GEOCRES No. 41J-33

SNOWSHOE CREEK BRIDGE  
GENERAL ARRANGEMENT  
KING'S HIGHWAY NO. 129. DIST. NO. 18.

FOUNDATION INVESTIGATION  
PROPOSED CROSSING  
SNOW SHOE CREEK - HIGHWAY 129  
TOWNSHIP OF CASSON

Subject: Snowshoe Creek, W.P. 14-74-04  
Site No. 38S-3  
Hwy. 129, District 18

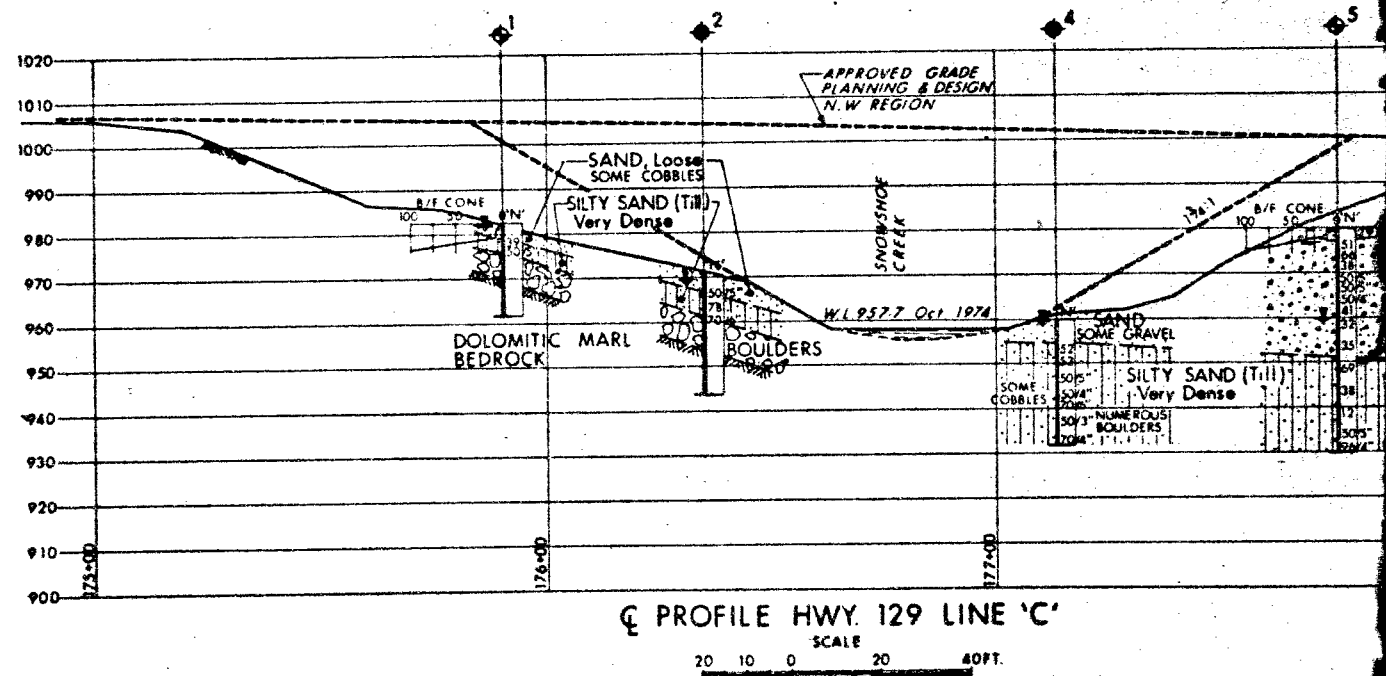
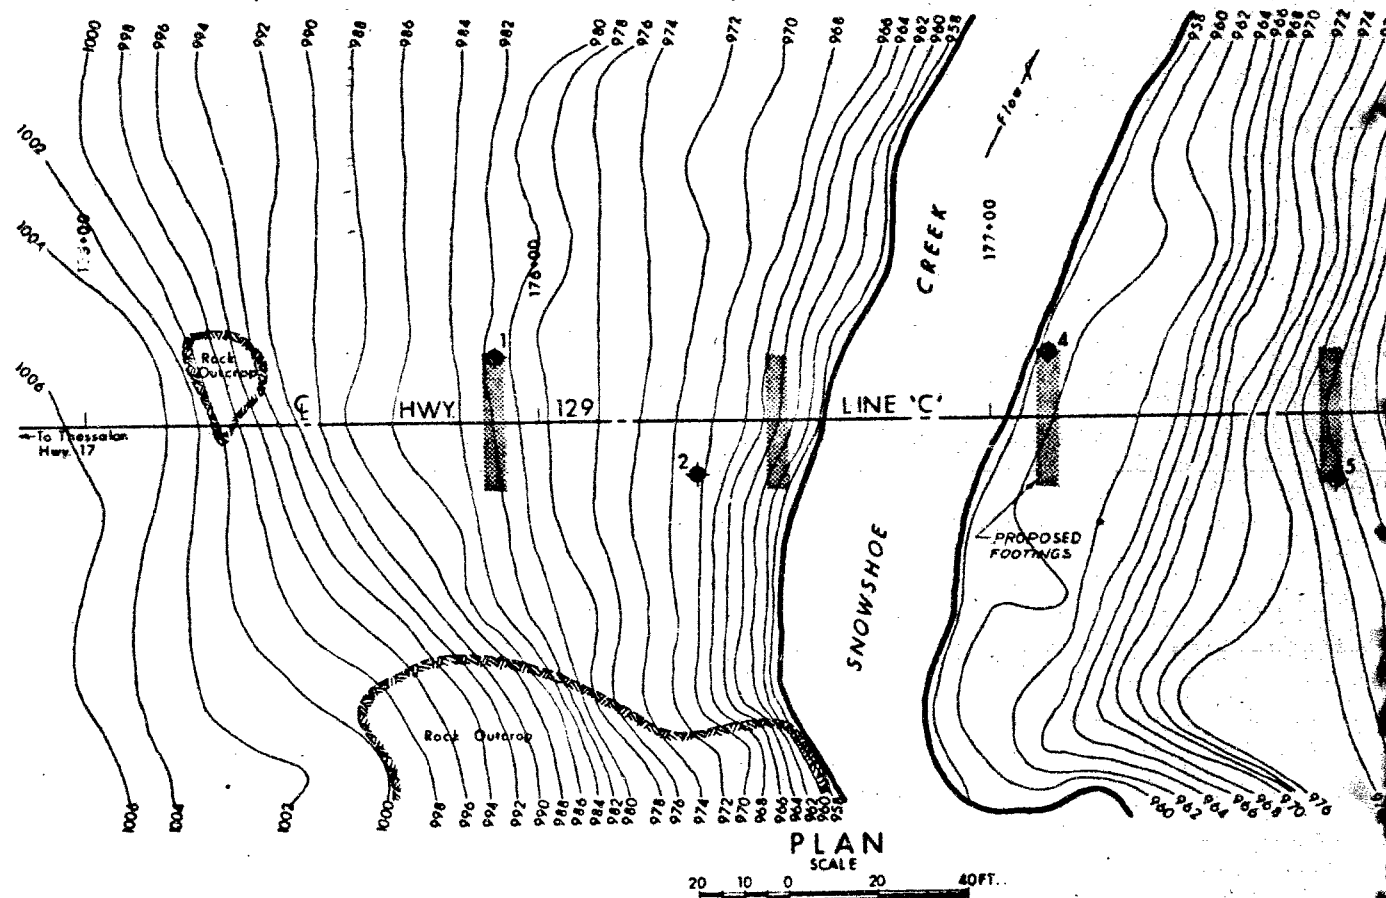
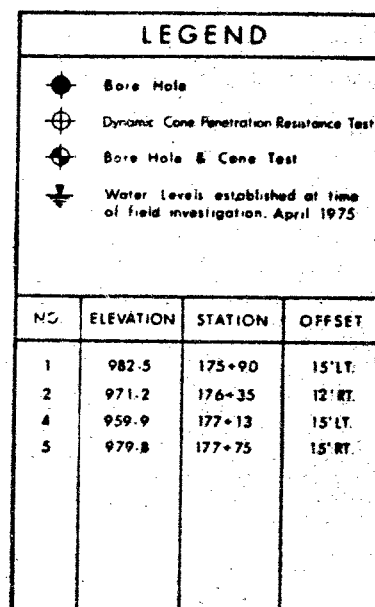
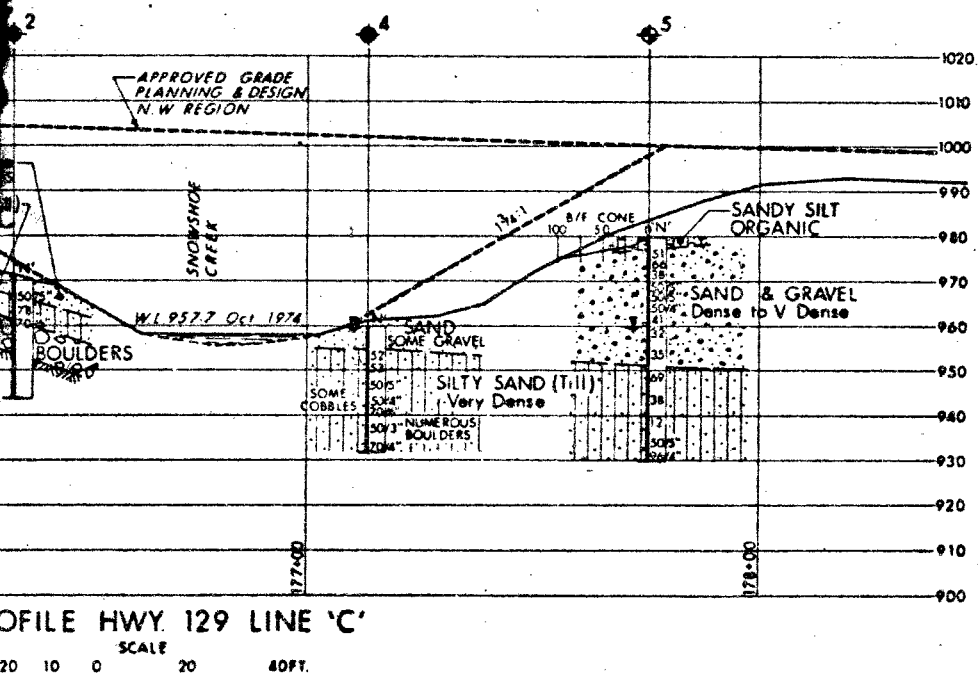
1. The Soils Profile, Dwg. 147404-A, indicates the presence of a surficial organic sandy silt deposit 1-2 feet thick in the vicinity of the north abutment. This soil should be completely excavated to its full depth within the plan limits of the approach embankments for a minimum distance of at least 25 feet behind the abutment prior to the placement of the approach fills.
2. We would like to draw your attention to our comments concerning items 2 and 4 of our memo to your Office dated January 6, 1976.
